**RE: Standard Dredge and Fill Wetlands Permit Application (RSA 482-A)
NHDES File Number: 2022-03478
Subject Property: Barrett Hill Rd, Wilton, Tax Map #A, Lot #44-1**

Per your request for more information dated February 21, 2023 please see clarification below and attached.

On behalf of the Town of Wilton Planning Board, Aries Engineering, LLC (Aries) prepared this letter report to describe our engineering review of available subdivision plans and the drainage report for a 7-Lot Subdivision, proposed by San-Ken Homes, Inc. (Applicant) of New Ipswich, New Hampshire, for an approximate 45-acre +/- parcel identified as Tax Lot A-44-1 (site property) and located on Barrett Hill Road in Wilton, New Hampshire. A site locus plan is depicted on Figure 1.

NH Wildlife Action Plan 2020 - Highest Ranked Wildlife Habitat

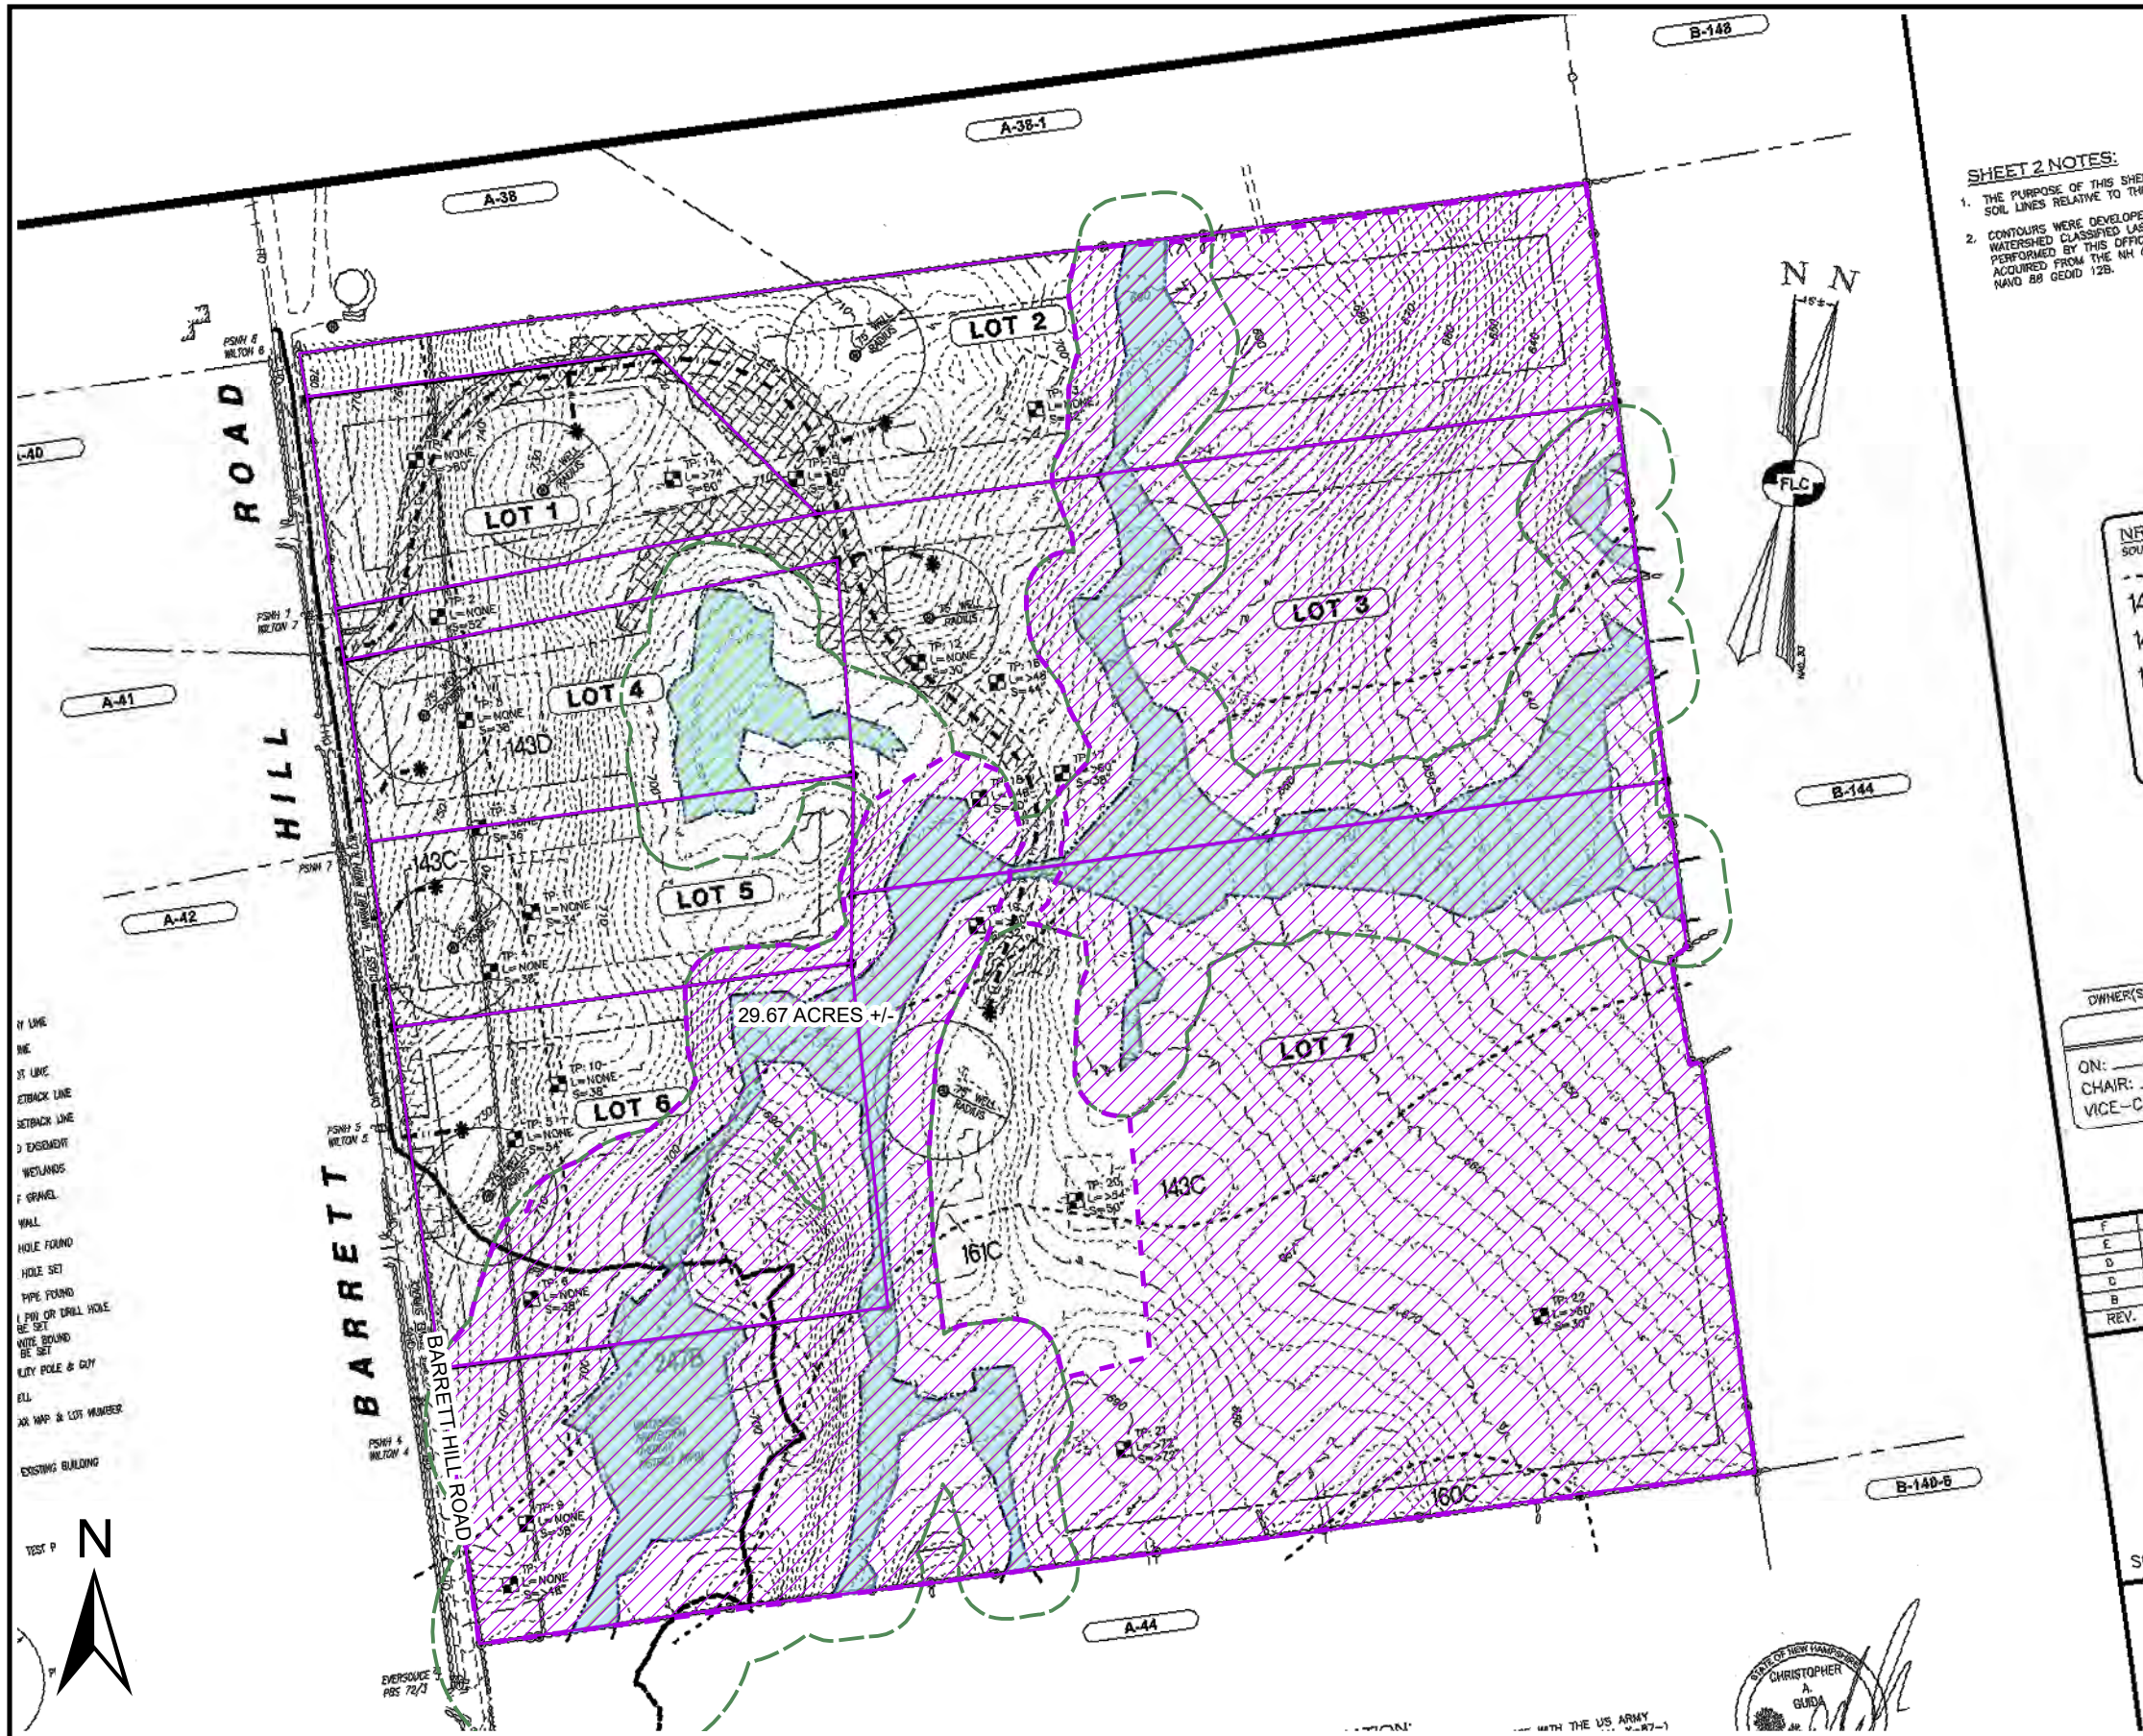
Review of the New Hampshire NH Fish and Game Wildlife (NHFG) Action Plan (WAP), updated in 2020, indicates that the majority of the site property is ranked as a “supporting landscape”, while the eastern portion of proposed Lot 2 is ranked as “Highest Ranked Habitat in Region”. Attached Figure 7 depicts an overlay of the NHFG WAP for the subdivision area.

TOTAL PROPOSED IMPACTS:
206 SF TEMPORARY IMPACT
769 SF PERMANENT IMPACT

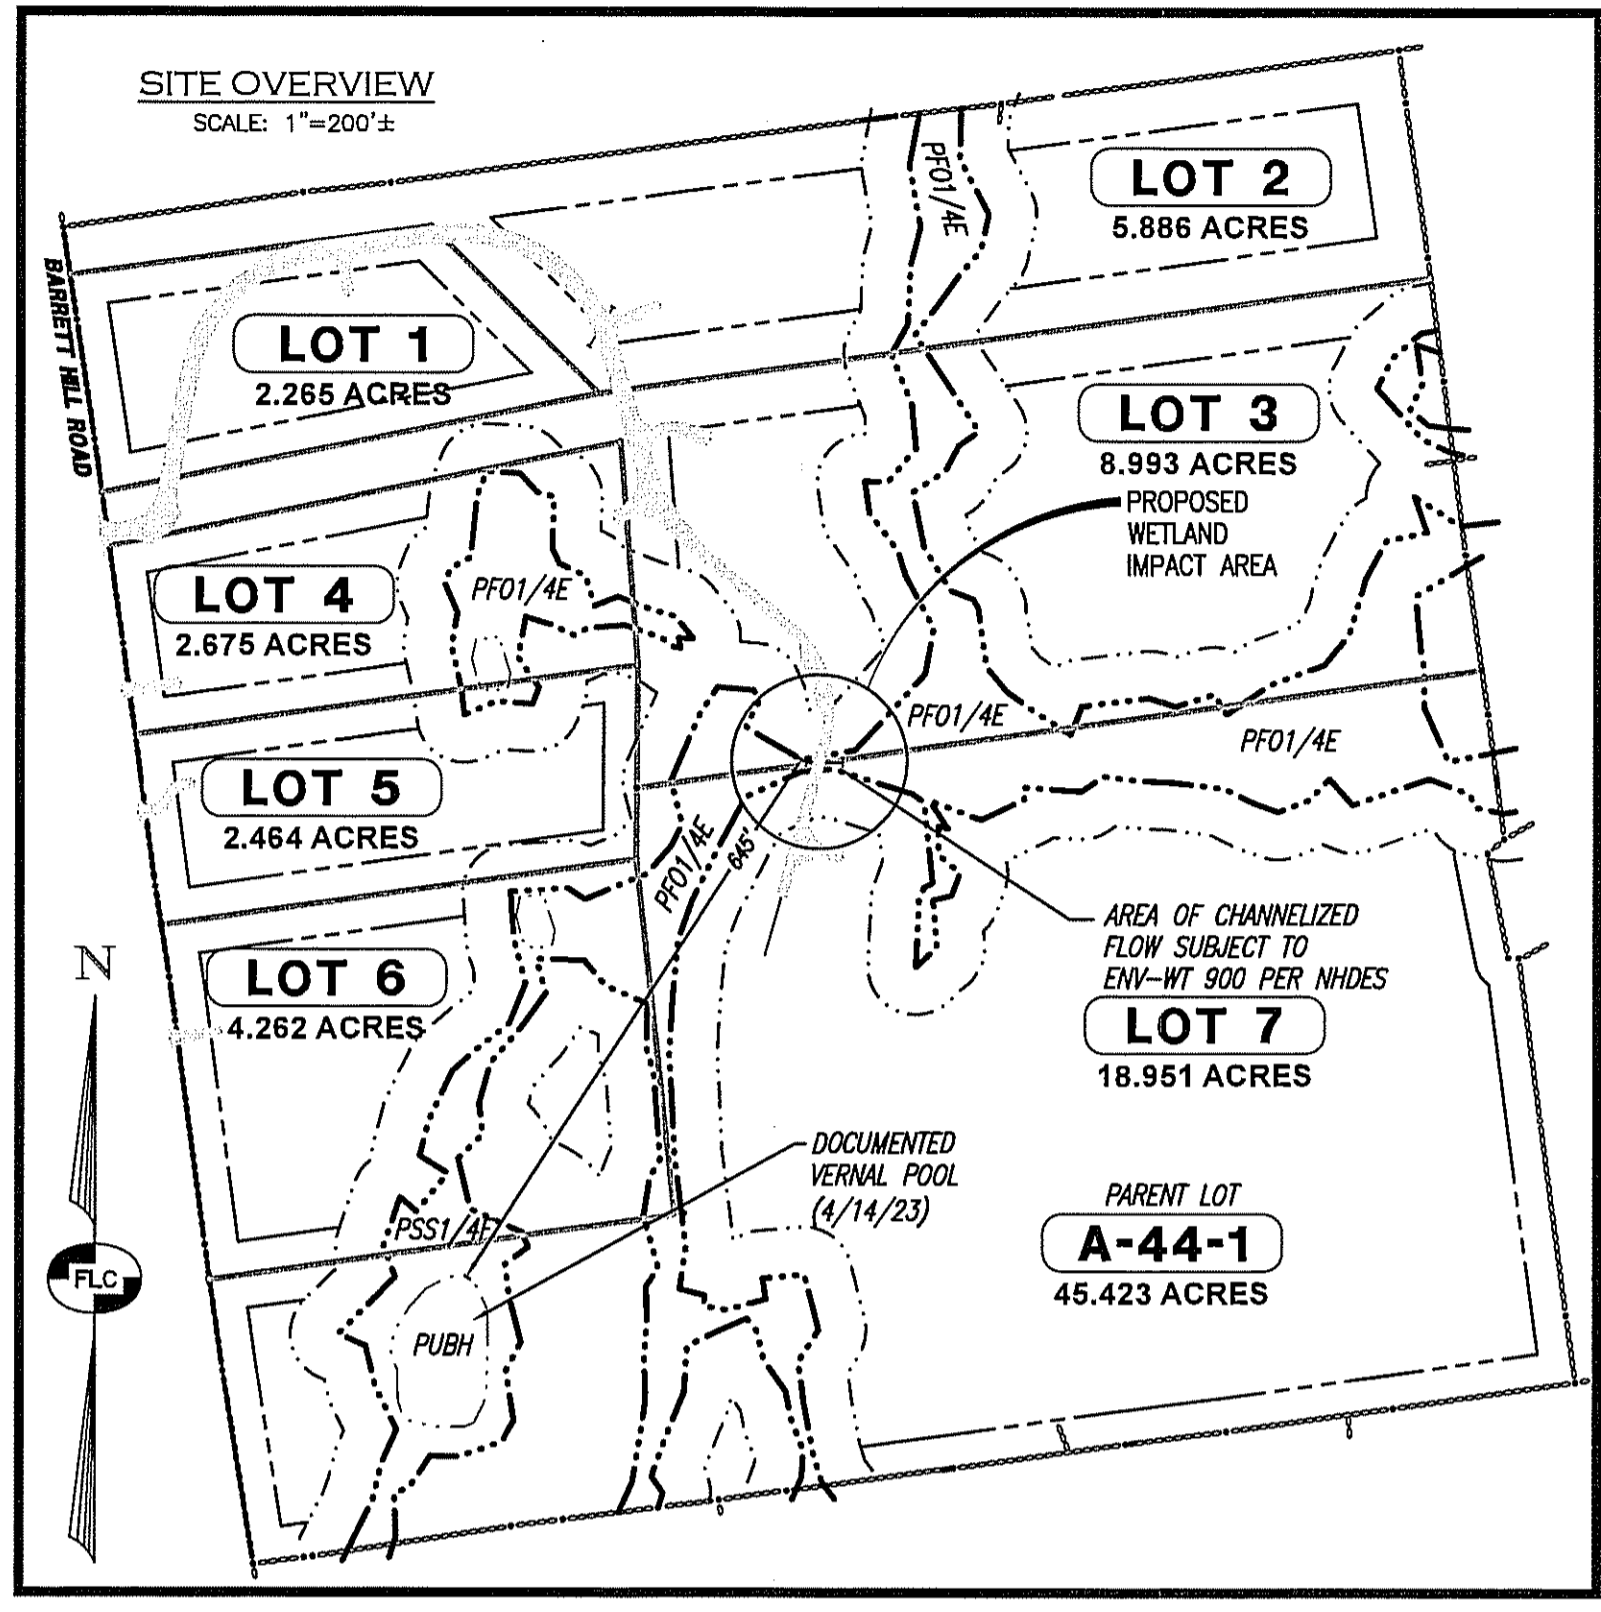
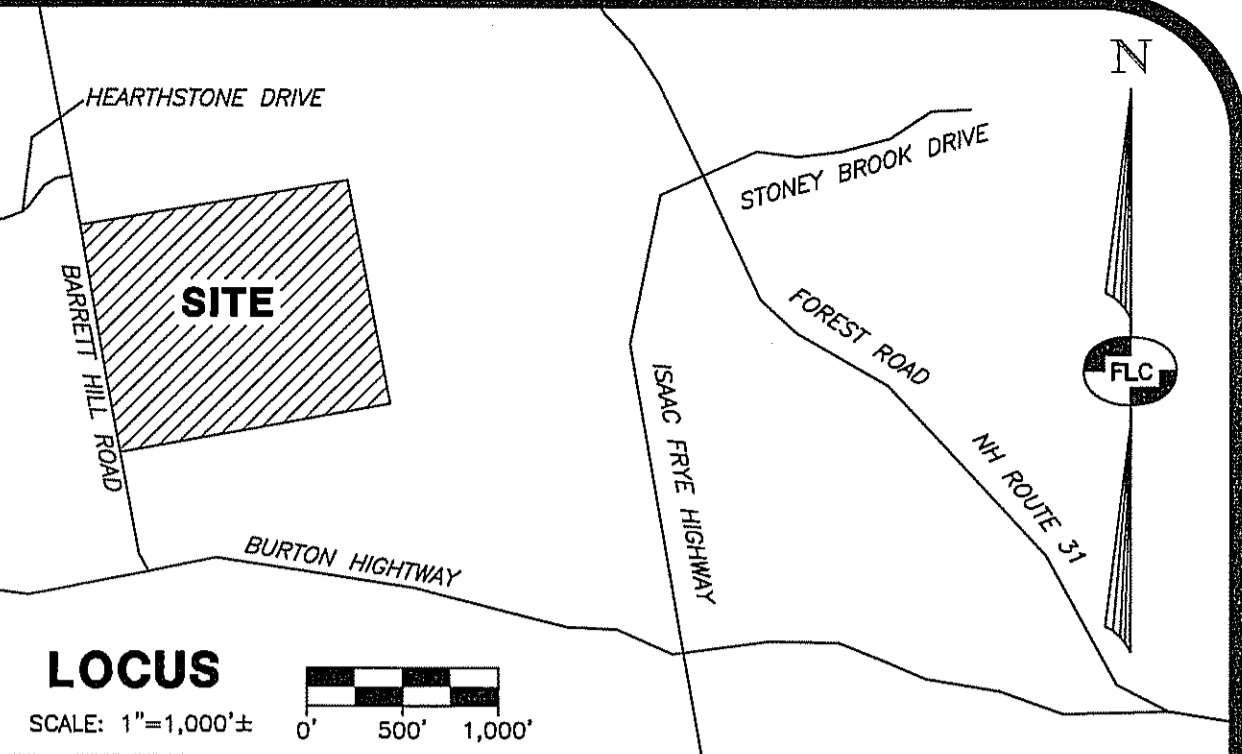
- a. Indicate the location of jurisdictional areas delineated on revised project plans in accordance with Env-Wt 311.05(a)(13) and Env-Wt 406, including the ordinary high water line (OHW).

- 4- Please remove the permitting note on the plan that says “THIS PLAN IS FOR NHDES WETLAND PERMITTING PURPOSES ONLY AND IS NOT TO BE USED FOR CONSTRUCTION OR ANY OTHER PURPOSE.” In accordance with Env-Wt 307.16, all work on the project shall be done in accordance with the approved plans.

All jurisdictional wetland areas have been delineated and are shown on the multiple plans submitted to NHDES. An approximation of the ordinary high-water mark has been added to the plan set per NHDES request. Watershed boundaries have been shown on the initial NHDES submittal. Portions of the watershed boundary was reviewed by Aries Engineering as part of a third-party review requested by the Town of Wilton. The watershed is less than 200 acres, which under Env-Wt 900 rules is a Tier 1 crossing. Photographs of the proposed impact area/wetland crossing were provided with the initial submittal. Additional photos are provided below:

There are additional engineering plans associated with this driveway design and wetland crossing. The intent of this note is to ensure the Wetland Permit Plan is not used independently for construction of the driveway, including the wetland crossing. Additional

information is required to properly construct the driveway. The Wetland Permit Plan shows proposed wetland impacts based upon the engineered driveway design and wetland crossing. The construction of the driveway is to be completed in accordance with the stamped engineering plans. The submitted Wetland Permit Plan shows all impacts and design features relative to wetland permitting as they are shown on the engineering plans. Should any changes to the engineered driveway design be required, an amended Wetland Permit Plan and application shall be submitted to NH DES.

Revised plans have been submitted along with the NH DES RFMI response. The proposed wetland crossing is shown at 1"=20' scale, while a site overview inlay is shown at 1"=200' scale. Three cross sections have been shown, however, selecting locations for these cross sections was limited as the period of observable continuous channelized flow is less than 100 linear feet.
